Re: Initial Submission Review – Highline Village Subdivision Filing No 3 – Plat Amendment
Application Number: **DA-2228-00**
Case Number: **2020-3013-00**

Initial Submission Review

HIGHLINE VILLAGE

**OVERALL
UTILITY PLAN**

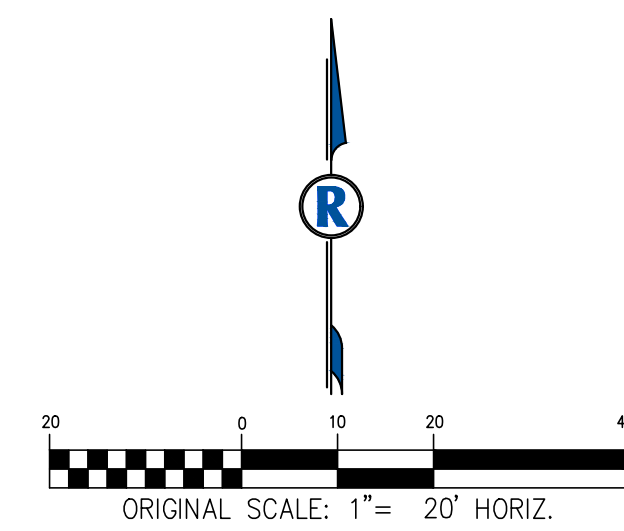
Add a note indicating if the storm sewer system is public or private and who will maintain it.

ITIG TR
PLA

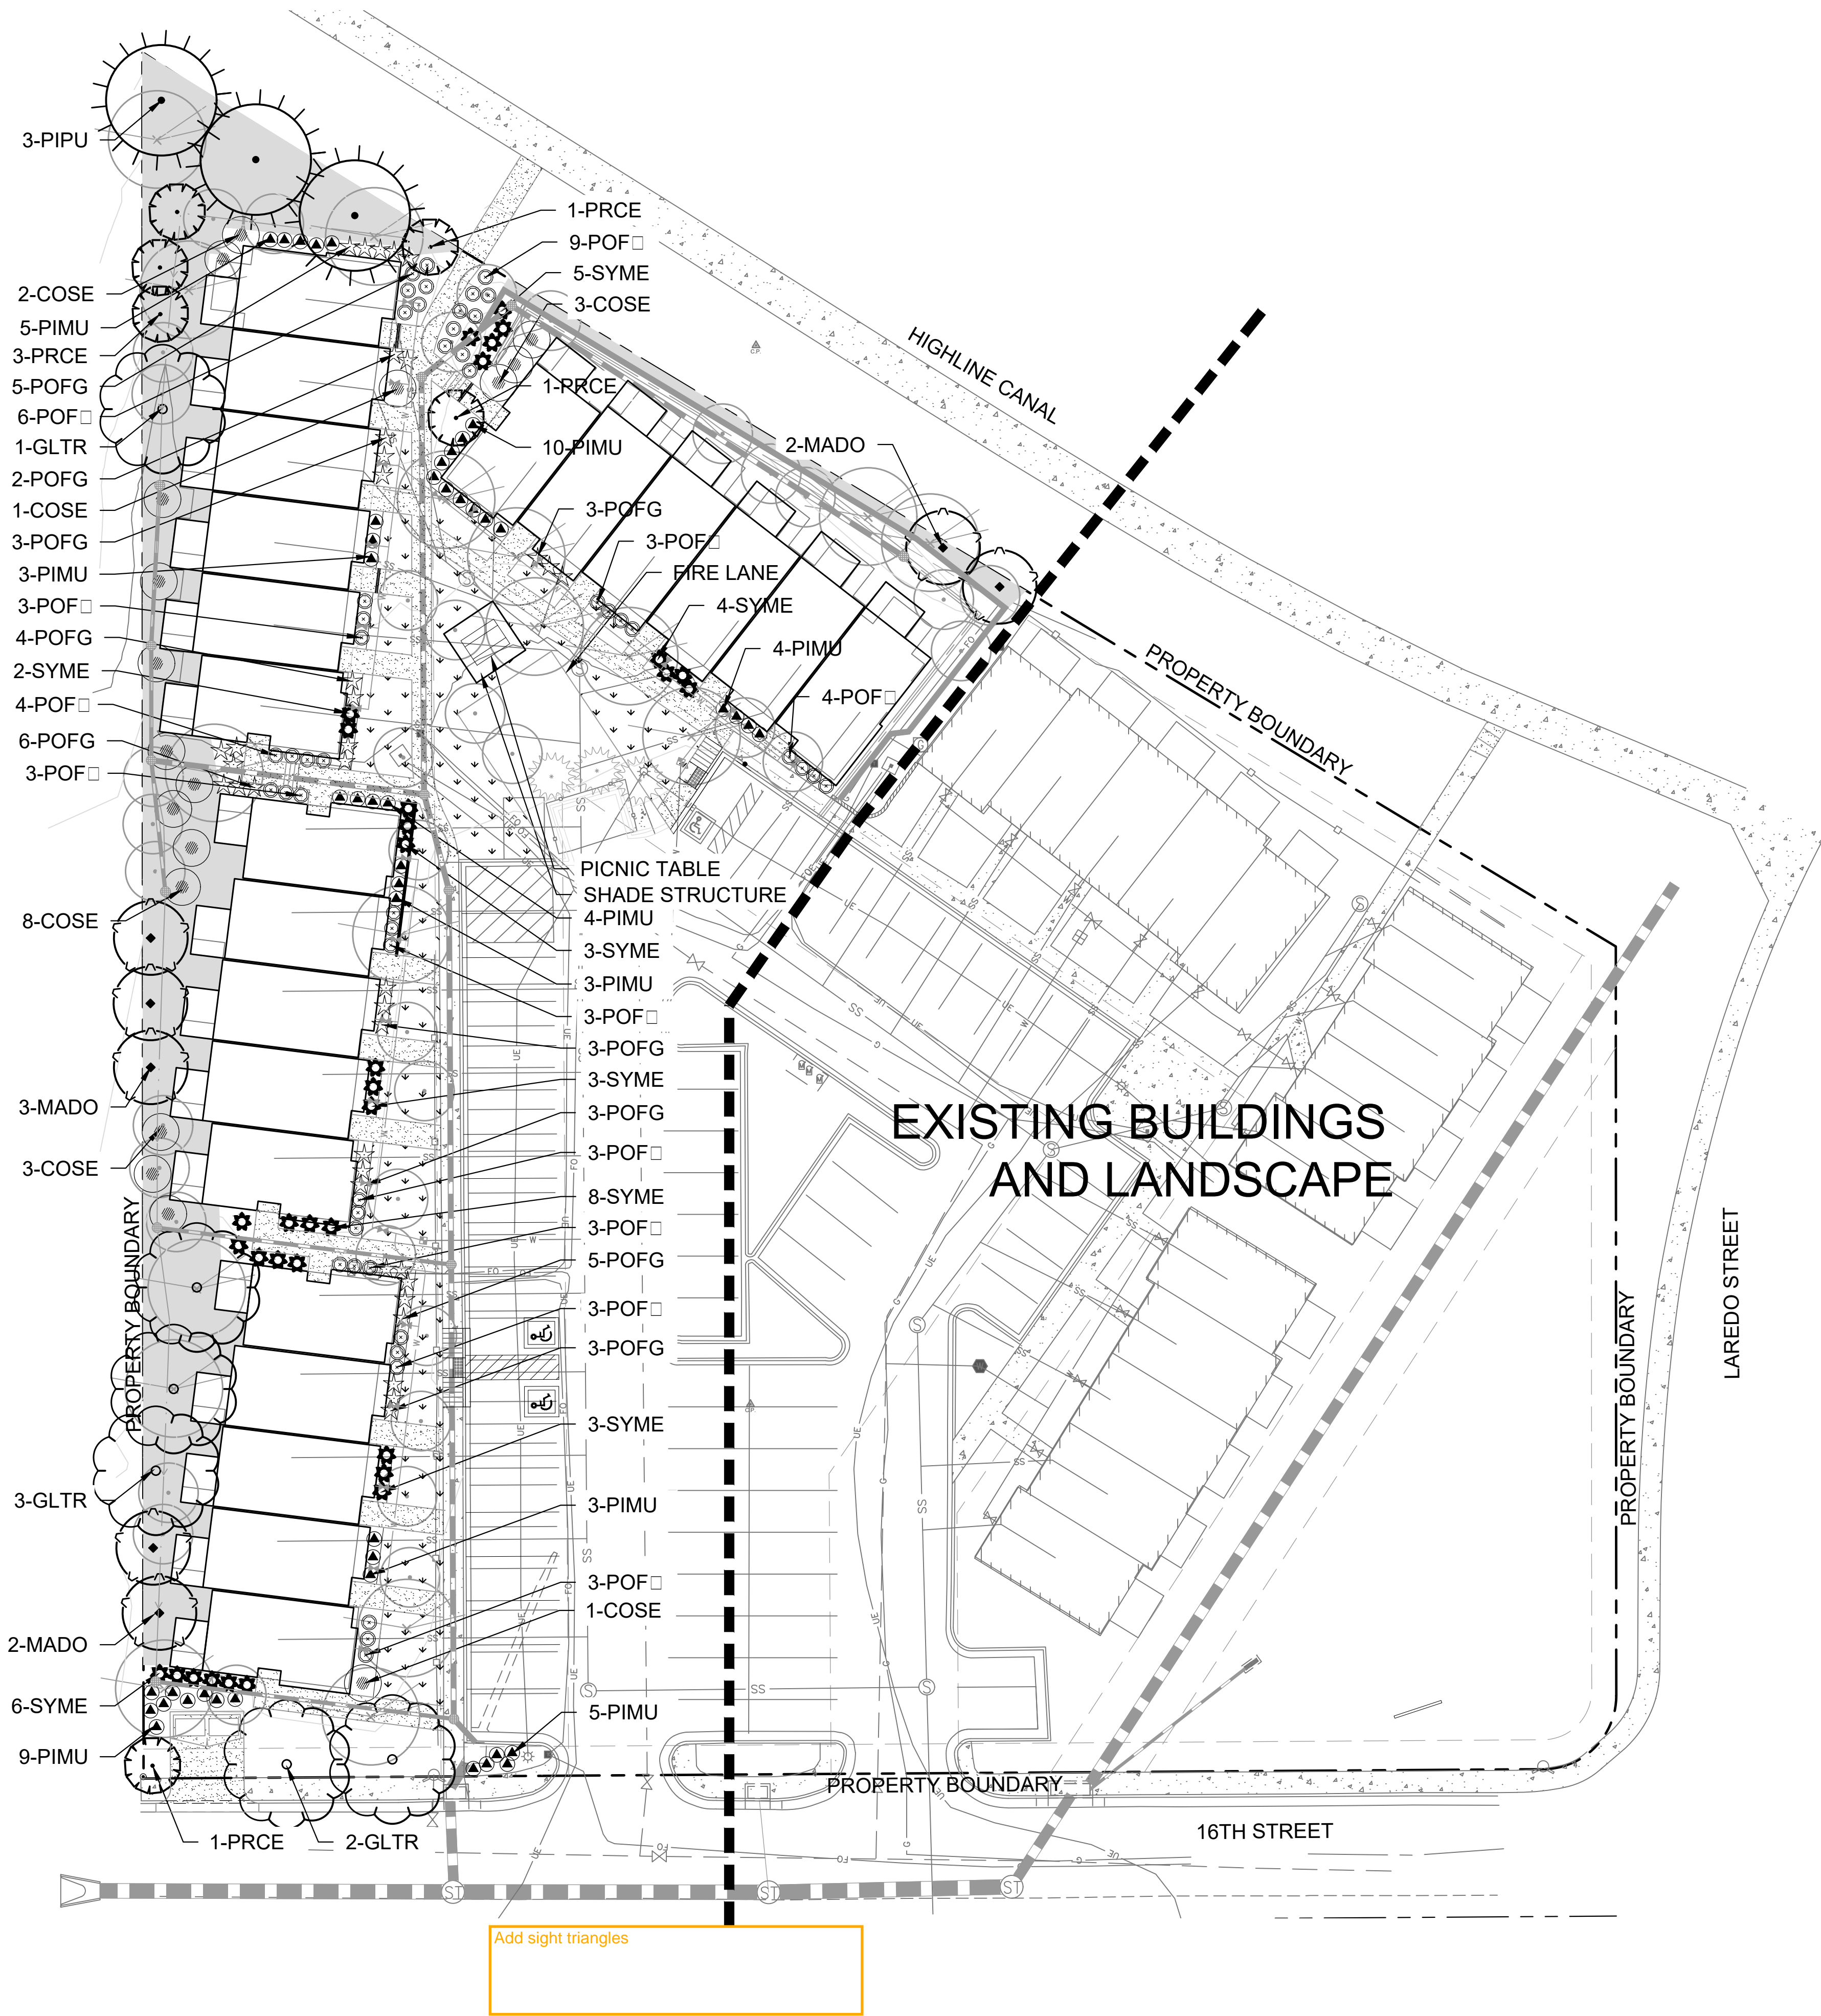
Any trees that are preserved on the site during construction activities shall follow the standard details for Tree Protection per the current Parks, Recreation & Open Space Dedication and Development Criteria manual. Parks, Recreation & Open Space Dedication and Development Criteria manual. These notes shall be added to the plan.

Please show a tree mitigation chart on the landscape plan taken from the Landscape Manual page 29. If payment will be made into the Tree Planting Fund, add another column to the chart indicating the payment amount that will be made. If trees will be planted on the site, please show a symbol indicating trees that are specific to tree mitigation.
